US 41
(Memorial Drive to County M)
Brown County
Project I.D. 1133-10-01

RECORD OF DECISION

October 4, 2011

FHWA-WISC-EIS-11-01-F

Figure 2
Proposed Ditch Realignment—County M Interchange

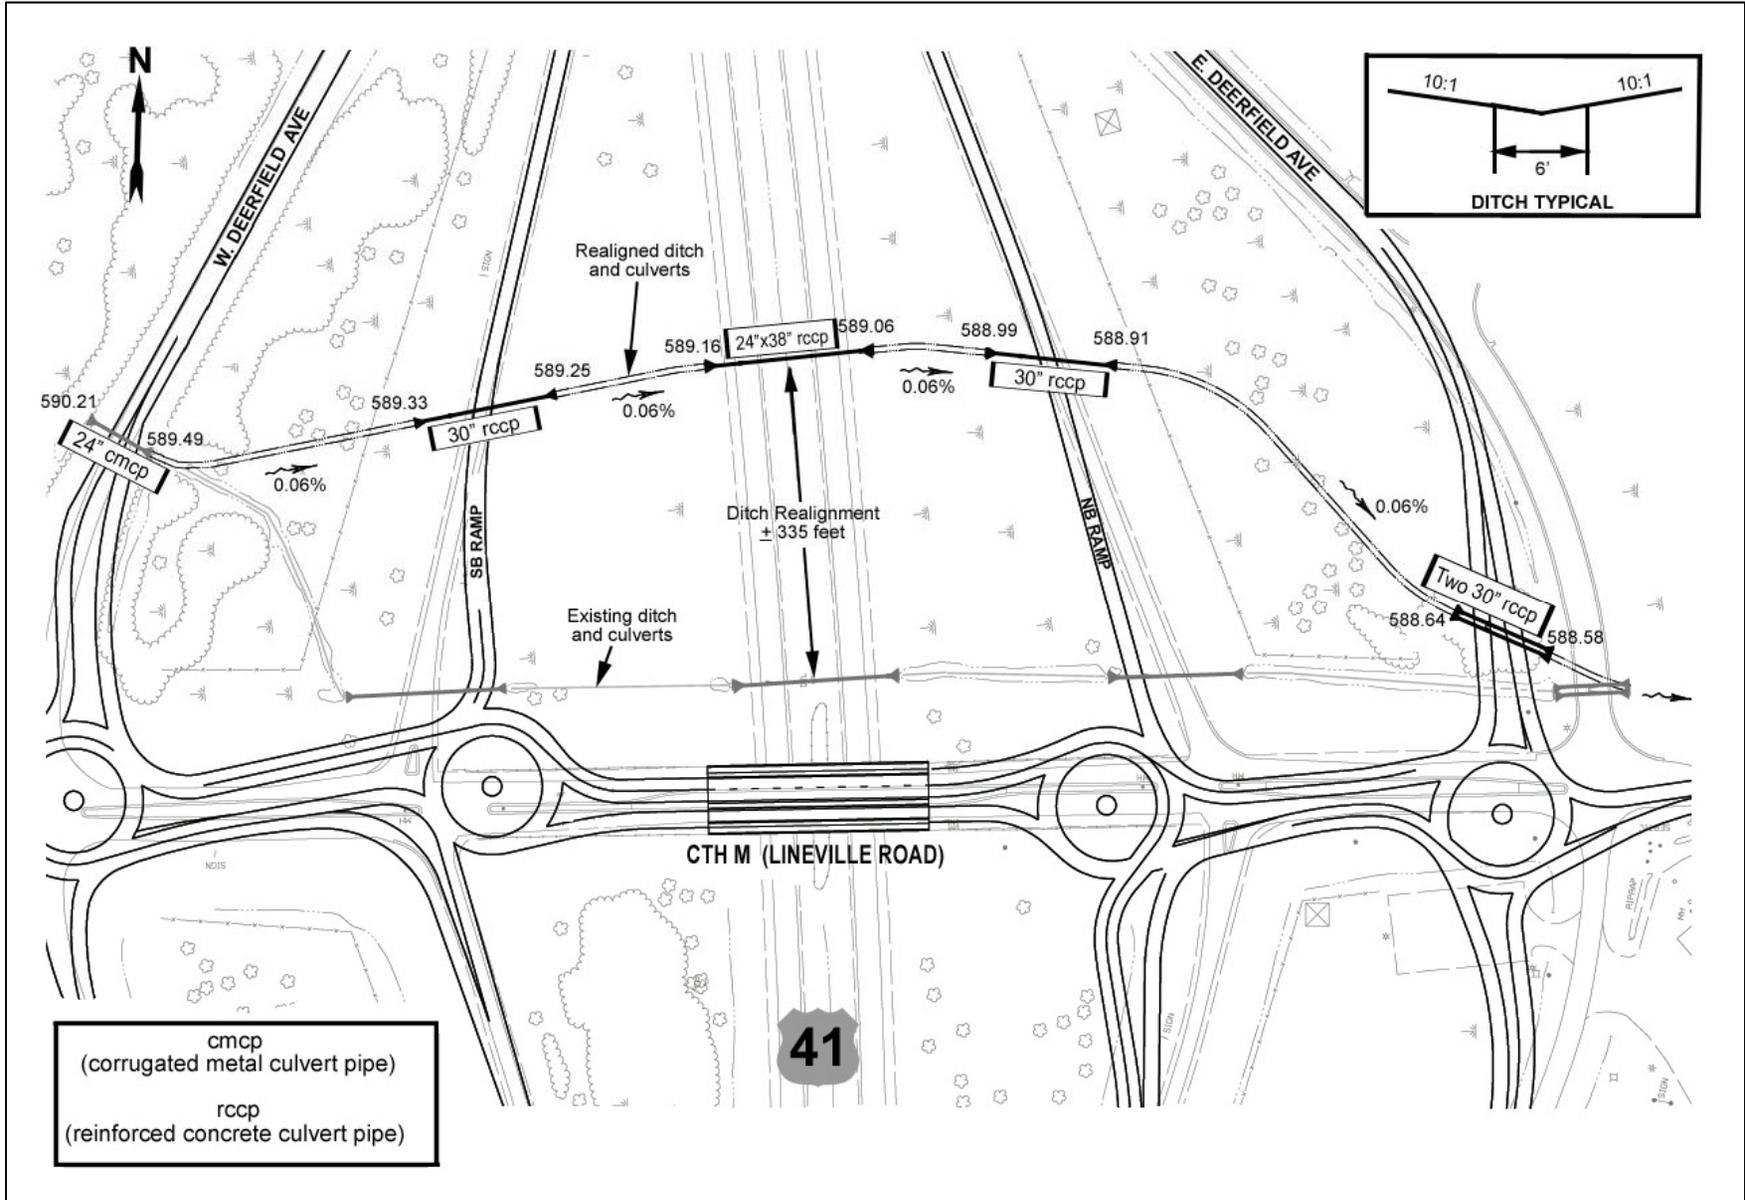
In their July 27, 2011 comments on the Final EIS (see letter in Appendix A) DNR noted that the Final EIS did not specifically discuss proposed realignment of the waterway that crosses the north half of the US 41/County M interchange, or mitigation measures that had been previously developed in consultation with DNR.

The existing waterway is a ditch that crosses US 41, the existing interchange ramps, and the existing frontage roads (East and West Deerfield Roads) just north of County M (see **Figure 2**). This ditch ultimately discharges to the bay of Green Bay and passes through wetlands within the interchange area. It also provides spawning habitat for Northern Pike. Ditch flow is from west to east through a 24" corrugated metal culvert pipe (cmcp) under West Deerfield Road, a 30" reinforced concrete culvert pipe (rccp) under the southbound exit ramp, a 30" rccp under US 41, a 30" rccp under the northbound entrance ramp, and two 30" rccp's under East Deerfield Road.

Proposed improvements at the County M interchange include constructing roundabouts at the interchange ramp terminals and at the frontage road intersections on County M. The interchange ramps and frontage roads will be realigned slightly to accommodate the roundabouts. The ditch will be shifted approximately 335 feet north of its present location to accommodate reconstruction of the County M interchange and to allow adequate cover for the US 41 mainline culvert.

Based on past coordination with DNR, the following measures were identified to minimize impacts to Northern Pike spawning habitat provided by the ditch:

- The new culverts will be essentially the same size as the existing culverts.
- The West Deerfield Road culvert will be replaced in kind and at its existing location to avoid disturbance to upstream wetlands and habitat. *This culvert will be replaced in kind in 2011 by the Village of Suamico due to its poor condition.*
- Minor adjustments to the culvert inverts will be made as needed to allow for an even channel slope across the interchange.
- The new ditch channel will have a “V” shaped bottom rather than a flat bottom.

Revised Beaver Dam Creek Realignment as presented in Final EIS

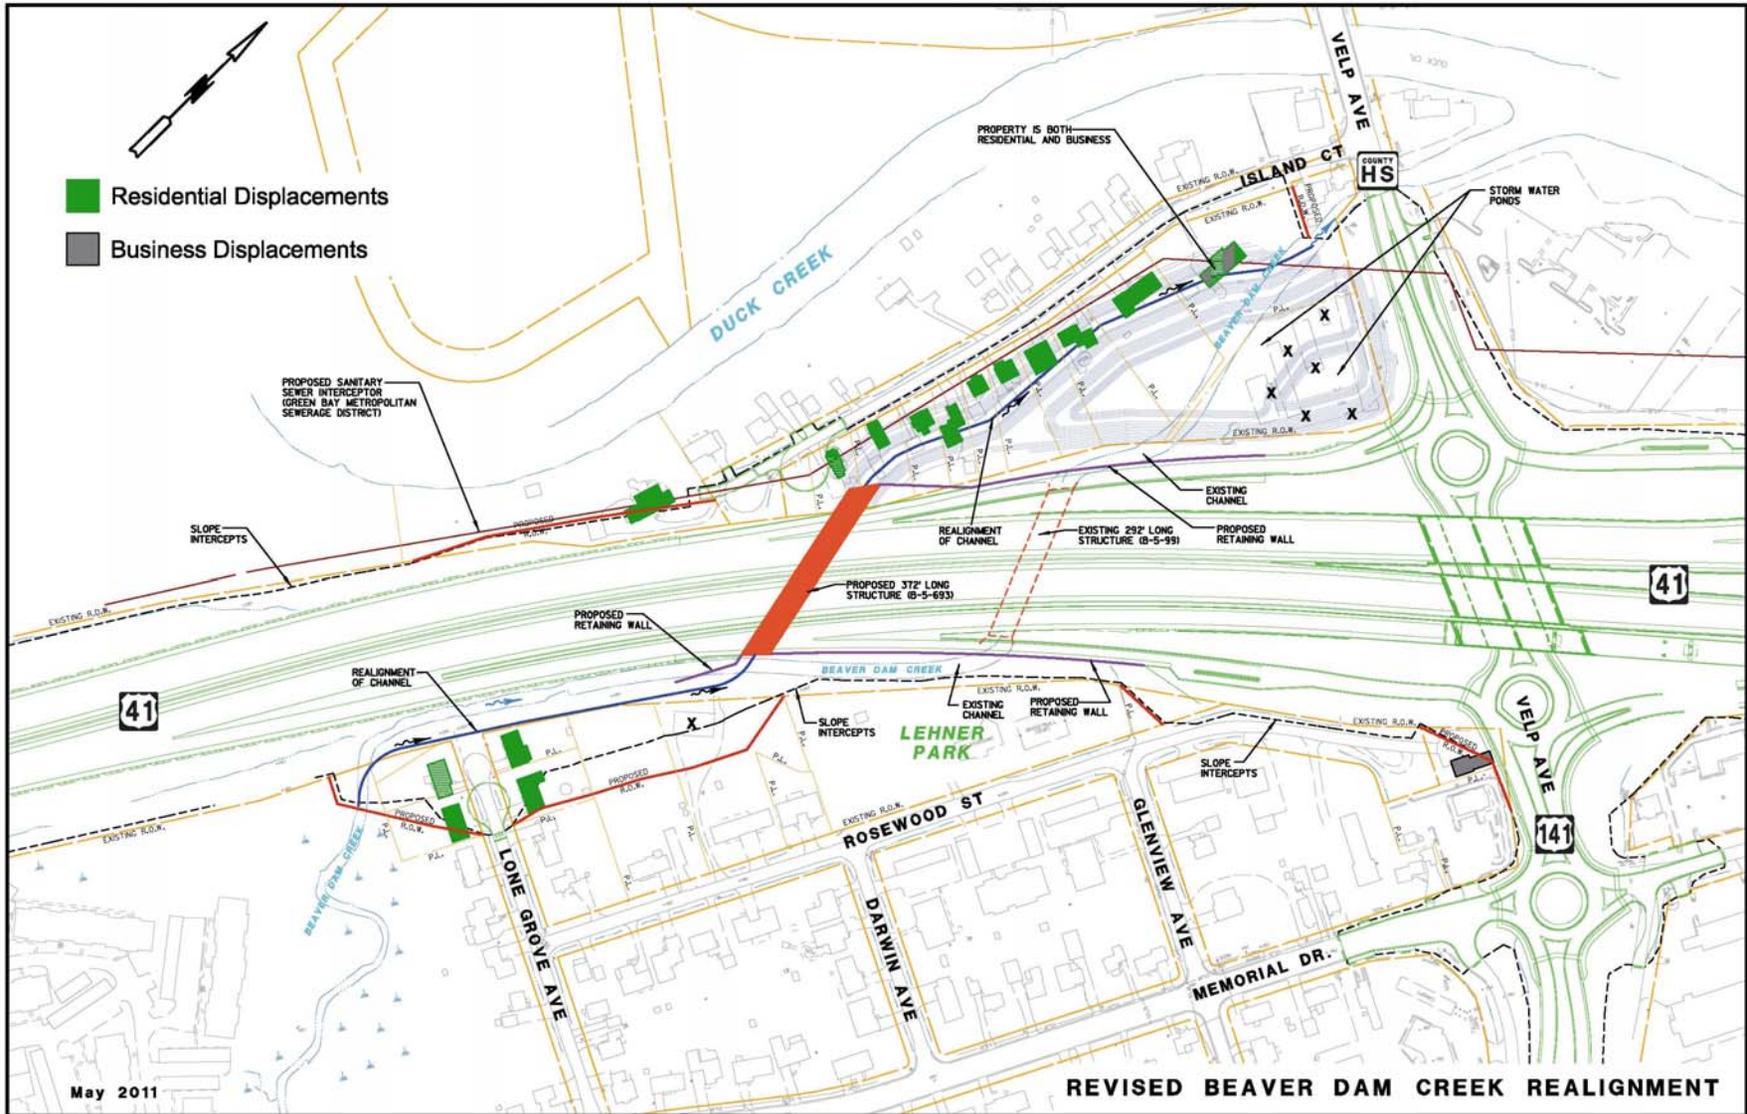
In their August 17, 2011 comments on the Final EIS (see letter in Appendix A) EPA recommended that the new Beaver Dam Creek box culvert on US 41 be a single cell structure with an open bottom. Or, if a multi-cell box culvert with a concrete bottom is used, EPA recommends that the bottom of the box culvert be placed at least one foot below the natural stream elevation.

As noted in the Final EIS, a four-cell box culvert similar to the existing structure is proposed, but with increased length to accommodate the wider US 41 roadway. Design details for the Beaver Dam Creek realignment are being developed in consultation with DNR and the USACE in conjunction with Clean Water Act permit activities. The overall objective is to enhance water quality and fishery resources. At this time, the design concepts and enhancement measures listed below are being considered. Additional habitat enhancement and sedimentation control measures will be explored further in the design phase in consultation with DNR and the USACE.

- Placing the bottom of the new box culvert below the streambed elevation to provide adequate water depth for fish passage and a more natural substratum through the box culvert.
- Planting trees/shrubs along the streambank to provide cover for the creek.
- Minimizing the amount of riprap used along the new channel to the extent practicable while still maintaining slope stability.
